## **Access Compliance Report Public Rights-of-Way** (Curb Ramps)

Intersection ID: 7480 Main Street: VANCOUVER DR Cross Street: WHITE PLAINS RD Location: N **Overall Compliance: No Severity Score:** 30 **ADA ID: F2EF5553F6B5** Ramp Type: BlendTrans1 Initial Pass/Fail: Fail

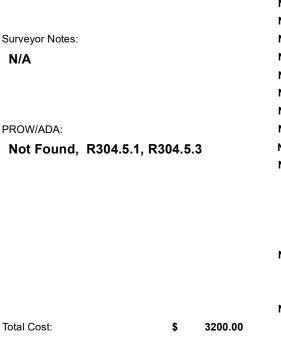
Compliance Description Data Compliance Description Data Yes BlendTrans Slope (%) N/A Ramp Length (in) 48.0 4.7 No No Ramp Width (in) 33.0 BlendTrans XSlope (%) 6.3 N/A Flare Type RT N/A Flare Type LT N/A N/A N/A Flare Slope LT (%) N/A Flare Slope RT (%) N/A N/A N/A Flare Traversable LT? N/A N/A Flare Traversable RT? N/A N/A N/A N/A DWS Provided? N/A Landing Length (in) N/A Landing Width (in) N/A N/A **DWS Contrast?** N/A N/A N/A Landing Slope (%) N/A DWS Length (in) N/A N/A Landing X Slope (%) N/A N/A DWS Full Width? N/A N/A Landing Curb? (Y/N) N/A N/A DWS Offset (in) N/A N/A N/A Shared Landing? N/A **Gutter Ponding?** N/A N/A Gutter Slope (%) N/A N/A Gutter Lip Ht (in) N/A N/A Gutter X Slope (%) N/A N/A Painted X Walk1? No N/A Painted X Walk2? N/A X Walk 1 Direction To SE X Walk 2 Direction N/A N/A X Walk 1 Width (in) X Walk 2 Width (in) N/A X Walk 1 Slope (%) 3.5 X Walk 2 Slope (%) N/A X Walk 1 X Slope (%) 4.1 X Walk 2 X Slope (%) N/A N/A N/A Ramp inside XWalk2? N/A Ramp inside XWalk1? N/A Road Slope (%) 4.1 Clear Space? N/A Road X Slope (%) N/A Clear Space to XWalk (in) N/A 3.5 N/A N/A N/A Any Obstructions? Storm Grate/Utility Hazard? N/A Obstruction Type Storm Grate/Utility Type N/A N/A Yes Surface Condition? (G/P) Good No 7.8 Curb Slope (%)

WHITE PLAINS RD Street 1 Name Stop Condition-Street 1 None N/A Street 2 Name Stop Condition-Street 2 N/A Remove & Replace Curb Ramp With Two New Directional Ramps or Equivalent.
